AMENDMENTS TO THE DRAWINGS:

The drawings are amended as described below by presenting replacement figures as attached hereto.

FIG. 1

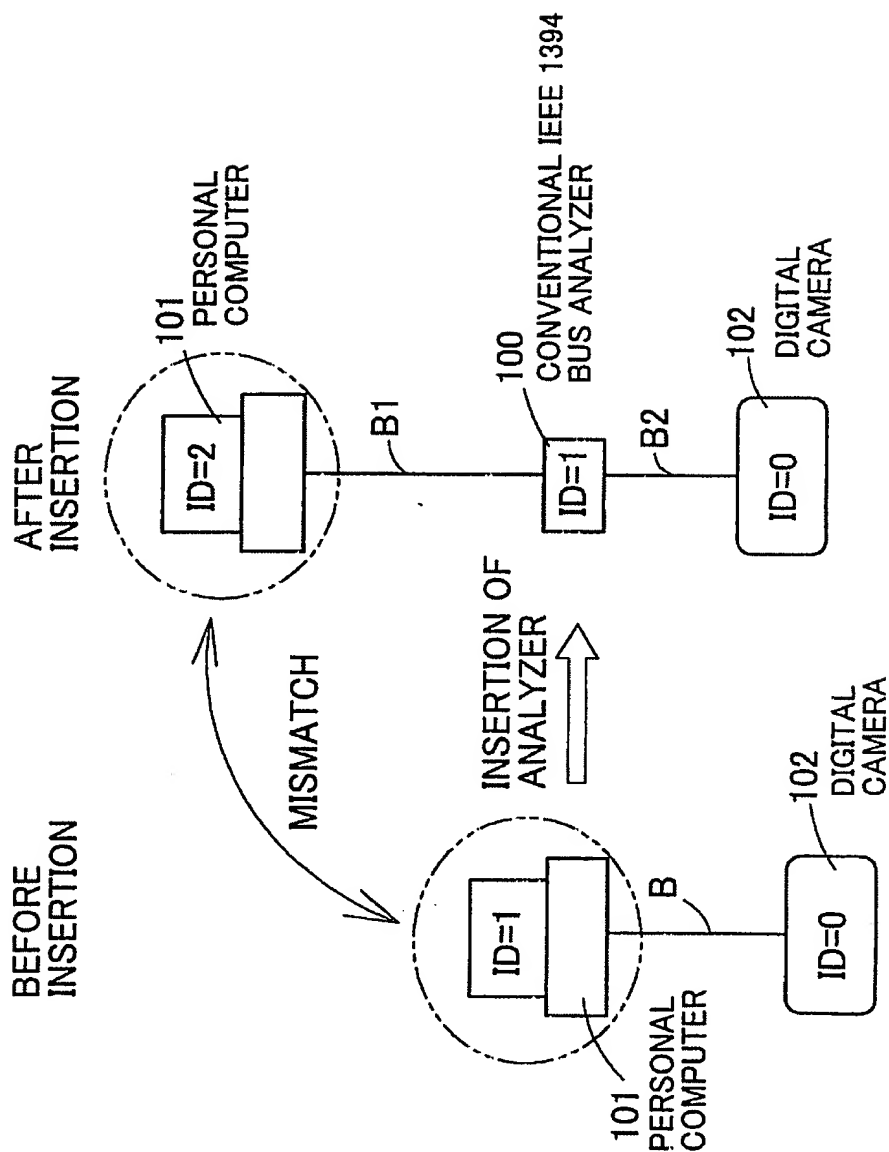
Figures 1 and 2 have been amended to include a legend identifying the figures as "PRIOR ART."
